Inter-Office Communication

TO: City Plan Board

DATE: Sept. 21, 2009

SUBJECT: **Petition PB-09-84:** Kimley-Horn and Associates, Inc., agent for S. Clark Butler Properties, Ltd. (Butler Plaza PD) Rezone property from Alachua County Automotive Oriented Business (BA), Retail Sales, and Services (BR), Highway Oriented Businesses (BH), Manufactured/Mobile Home Park (RM), Manufacturing and Services Industrial (MS), Residential Multi-Family (R-2), Residential Multi-Family (R-3), Residential Single Family (R-1C), Residential and Professional (RP) to City of Gainesville PD (Planned Development District) to allow commercial, office and residential uses. Located between Southwest Archer Road and Southwest 24th Ave., and between Southwest 40th Blvd. and Southwest 34th St. Related to Petition PB-09-74 LUC.

**SW 62nd Blvd Connector
Adopted Alignment**

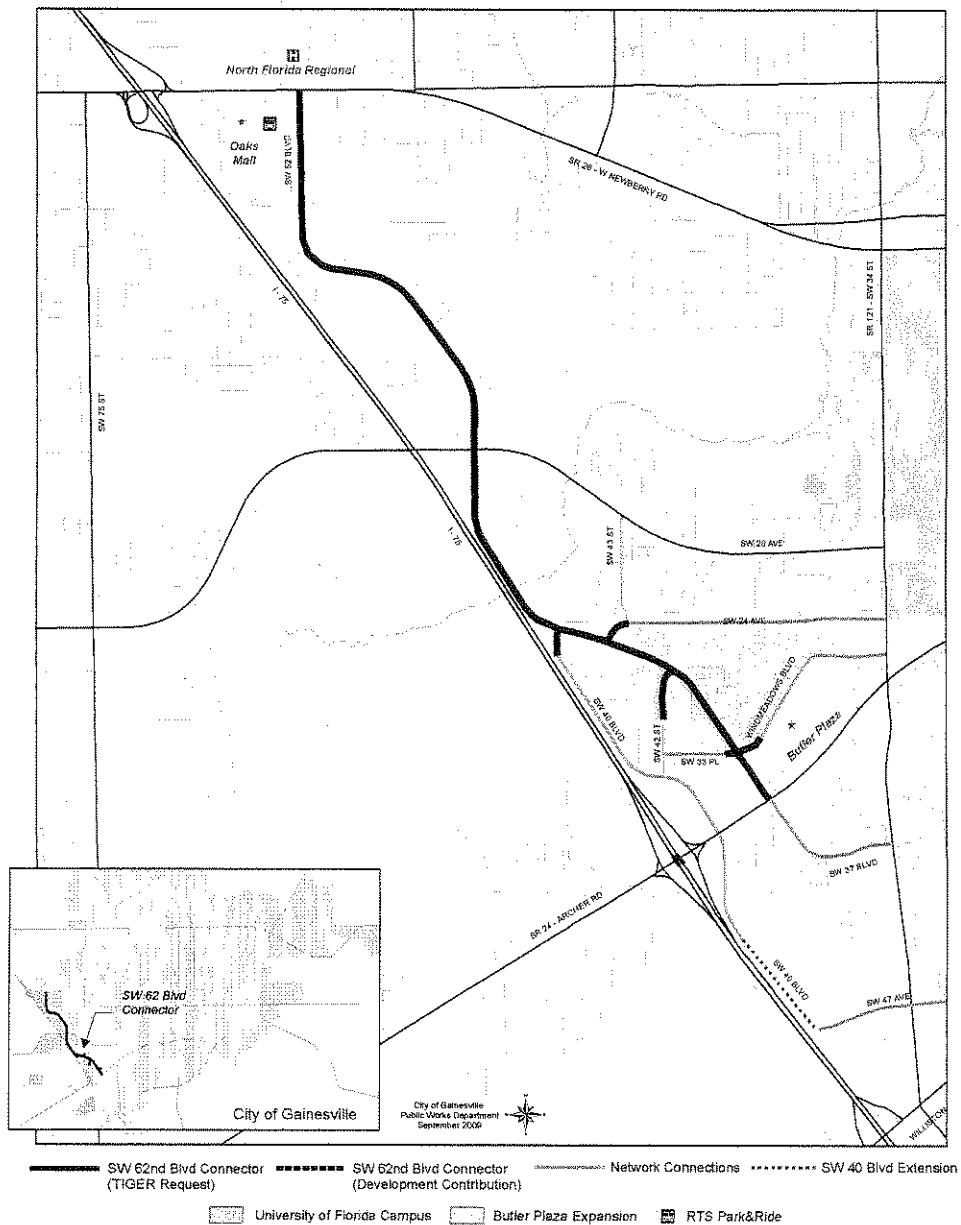
The City has already submitted a grant application to the USDOT for the extension of SW 62nd Boulevard, which will create a new connector between Newberry and Archer Roads, and will be an alternative route to I-75. The grant is a Transportation Investment Generating Economic Recovery (TIGER) grant under the American Recovery and Reinvestment Act (ARRA). At the latest, the City will know the status of the grant application by February 17, 2010. The proposed alignment and configuration of the road was approved by the Metropolitan Transportation Planning Organization (MTPO) on March 2, 2009. The road design consists of four general purpose lanes plus two additional lanes in the median for bus rapid transit. Bicycle parking and storage facilities will be provided at bus rapid transit stations and park-and-ride facilities. The adopted alignment for this road is shown on the following page, and the proposed PD Layout Map is consistent with this road alignment.

Part of the developer's TCEA mitigation will be construction of a portion of the proposed SW 62nd Boulevard extension. An analysis performed by HNTB indicated that an average congestion reduction in the range of 2% to 11% is anticipated as a result of this project. The highest congestion reduction is on SW 20th Avenue (11%), with a 2% reduction shown on I-75 between Archer Road to Newberry Road. As redevelopment occurs in the Butler Plaza Subarea 1 section, measures should be taken to ensure that the configuration of SW 62nd Boulevard extension from Windmeadows Boulevard to Archer Road is consistent with the approved design for the northern section of the road.
